December 8, 2017

ND-17-2032
10 CFR 50.55a

Southern Nuclear Operating Company
Vogtle Electric Generating Plant Units 3 and 4
Response to Request for Additional Information Regarding Application of VT-1 Visual
Examination Methodology for Preservice Inspection of the
Reactor Vessel Nozzle Inner Radius Sections (VEGP 3&4-PSI-ALT-07S1)

**Response to Request for Additional Information Regarding Application of VT-1 Visual
Examination Methodology for Preservice Inspection of the
Reactor Vessel Nozzle Inner Radius Sections (VEGP 3&4-PSI-ALT-07S1)**

Figure 1. Probability of Correct Rejection Sizing, Acceptable Flaw Size 0.15 (Reference 1)

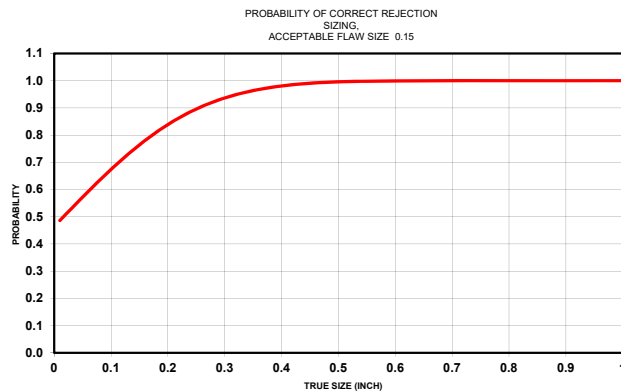
The request notes that you plan to adopt Code Case N-648-1, "Alternative Requirements for Inner Radius Examinations of Class 1 Reactor Vessel Nozzles," for future ISI, however, even though you do not reference Code Case N-648-2, it appears that your technical basis for application of VT-1 for PSI is based on that code case. Code Case N-648-1 applies only to ISI and is conditionally approved for use by the NRC in Regulatory Guide 1.147, "Inservice Inspection Code Case Acceptability, ASME Section XI, Division 1." Code Case N-648-2 applies to both PSI and ISI, and is currently being reviewed by the NRC staff for incorporation into Regulatory Guide 1.147 based on comments provided during ASME Code meetings. Please confirm that you are basing application of VT-1 for PSI on Code Case N-648-2 and discuss how you have addressed potential NRC staff comments regarding use of this code case for new reactors with no previous operating experience.

Figure 1 depicts the expected rejection probability as a function of flaw size, documented in Reference 1. Correct rejection probability considers the detection capability and the sizing capability for flaws. For example, as shown in Figure 1, the probability of detecting and rejecting a flaw 0.25" into the base material is equal to or greater than 90%.
